Ref. No: WCL/ENV/HQ/8-K & 20 -C/ 506

Sub:- Expansion of Naheriya Underground Coal mine Project from 0.36 MTPA to 0.54 MTPA of Western Coalfields Limited within existing ML area of 300 Ha located in Tehsil Parasia, District Chhindwara (Madhya Pradesh) under Clause 7(ii) of the EIA Notification, 2006.

Ref:- Meeting Minutes of 53rd & 62nd EAC Meeting.

Compliance Report
on
Issues Discussed
&
Additional Information Sought
in 53rd & 62nd EAC
For
Naheriya UG Expansion,
Pench Area,
Chhindwara (M.P.)

Fig.3: Schematic Diagram of AMD Treatment Plant at Naheriya UG

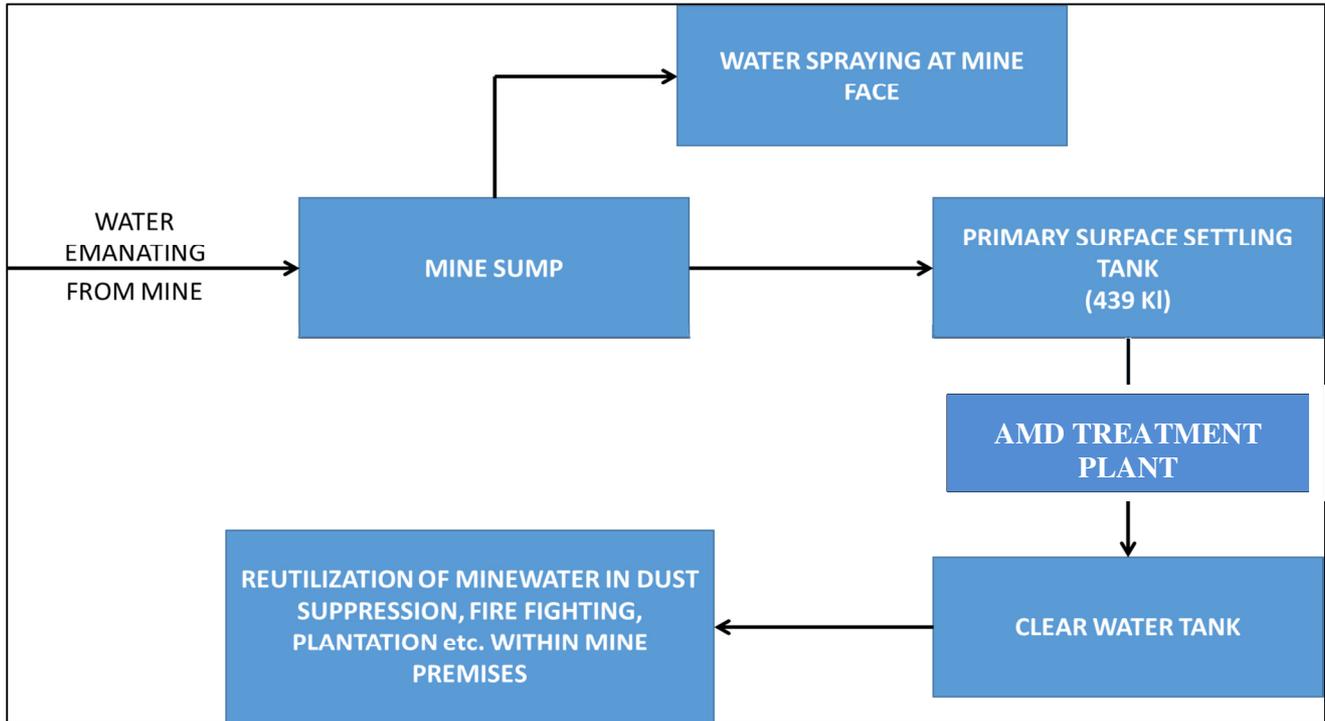
S.No	Issues Raised	Reply
1	Volume of water treated	Average of 298 KLD water (Table-1) is being treated in the Acid Mine Drainage Treatment system
2	Dosage of lime	0.04 grams/liter of lime is being used.
3	Disposal of Waste Residue	As mentioned above 16.2 kg per day of Sludge will be generated. On regular basis Sludge will be removed. Characteristics of Sludge (Enclosed as Table-3) are not hazardous and will be utilized as fertilizer for plants or disposed along with other domestic waste.
4	Use of Treated water	The treated water is completely utilized within the premises for Dust suppression, Firefighting & for plantation (Photographs-3 shown above)
5	Enhancement of pH from 6.9 to Neutral (± 7.2)	pH achieved after present treatment is neutral (6.0 – 7.0) (Table-2, 2.1 & 2.2 showing parameters before & after treatment)
6	Characteristics of Water before & After treatment	Water quality analysis is given in Tables – 2, 2.1 & 2.2

Mine discharge is of pH value 3.5, after treatment in stages, this value reaches to around 7.00. The treatment methodology given in following steps:

Initially, Lime dosing is done at underground mine sump (0.04 g/l), then the water is pumped to surface settling tanks (Capacity – 439 KL) with a detention time of 4 hours and from there water is pumped to Tank-1 (18 x 6 x 3 m) for preliminary treatment.

After preliminary treatment (Stage-1), water is taken to 2nd tank where Limestone chips (Commercial name – marble dana – 1” size) is used as bed of the tank. The capacity of the tanks is 160 KLD (80 + 80). Dimension of the

Typha latifolia plant is planted at close spacing of 10 cm. Long detention period of water with this plant is very important, only then the plant will show its efficacy. CMPDIL has suggested a detention period of 24 hrs. For providing such a long detention period, the size of the tank must be commensurate with the quantity of water pumped out daily. The dimension of the tank is 30m*15m*1m i.e. 450 m³ or 450 KL.

Fig-4 : Seasonal Wind rose Plot Diagram

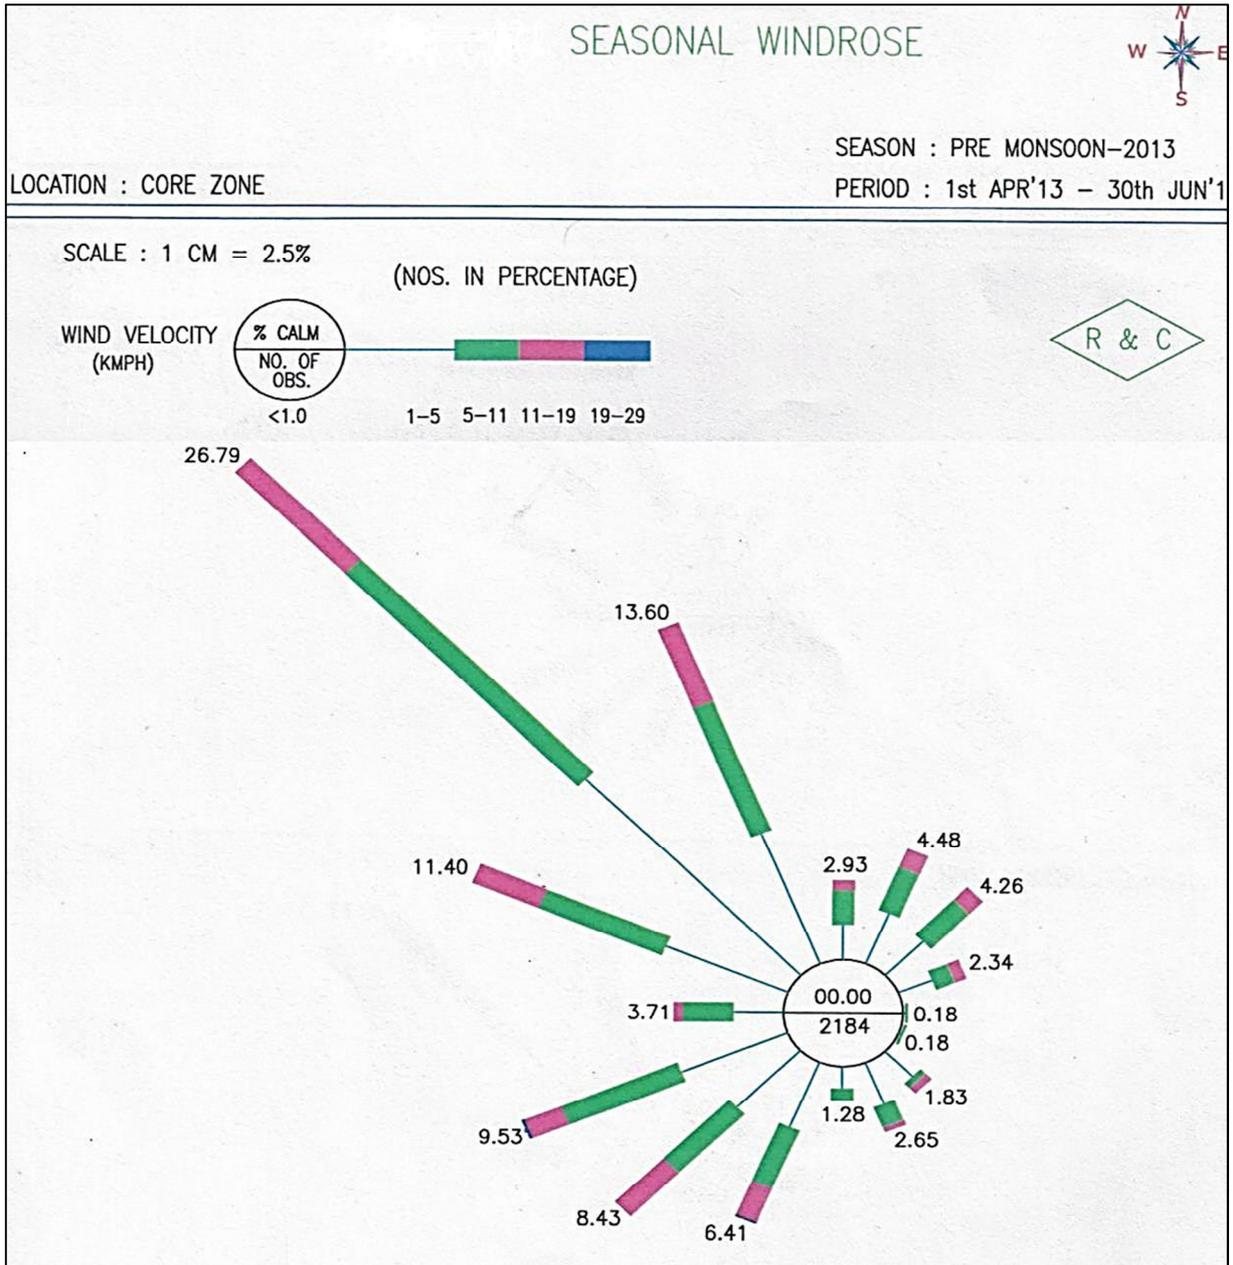
Above Permissible Air Quality (PM₁₀) Values in Naheriya Village: EAC pointed that the air quality in Naheriya village is above permissible standards (Ambient Air Quality Standards).

4. It can be observed from wind rose diagram that predominant wind direction during most of the time is from North-West i.e. most of the time wind flows from North-West direction to south east direction.

5. From the above it can be inferred that above permissible Air quality standards at Naheriya Village is not due to mine operations & allied activities but could be due to local phenomenon (unpaved roads, use of wood/coal for cooking, storm dust etc.)
